REMARKS

U.S. Serial No.: 10/695,754

V. Chan et al.

FIGURE 1

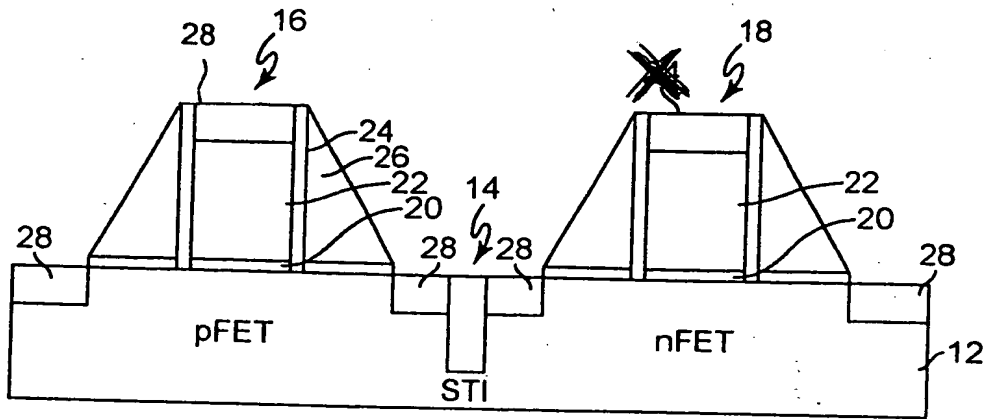
Please approve the deletion of reference "24" in Figure 1, as shown in red on the marked-up copies (Annotated Marked-Up Drawings), and substitute therefore the attached Replacement sheet of Figure 1 which implements the change.
